FT-5500 MK II MOD. RIGHT CHANNEL SHOWN

03 NOV. '04  
RBM

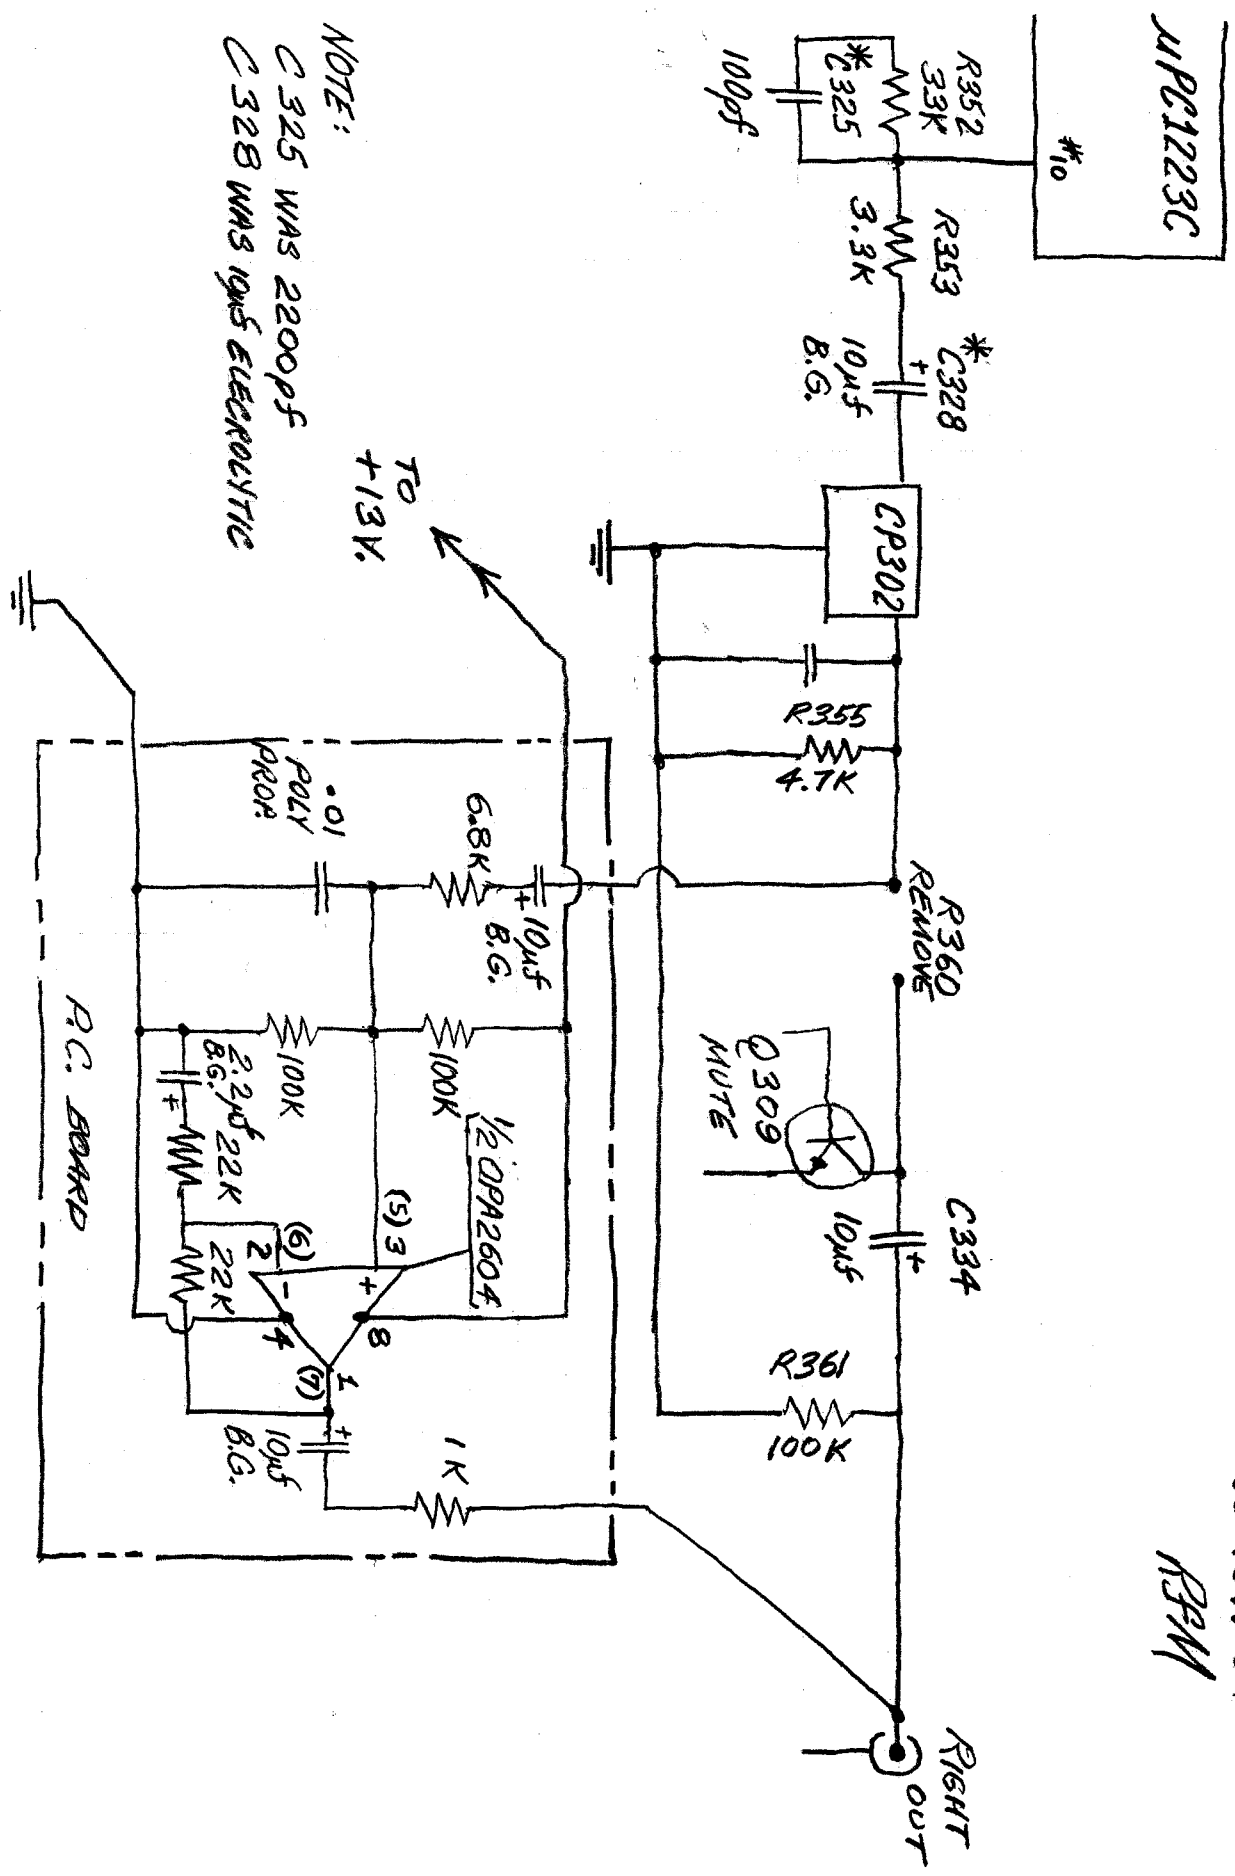
NOTE:  
C 325 WAS 2200pf  
C 328 WAS 10µ5 ELECTROLYTIC
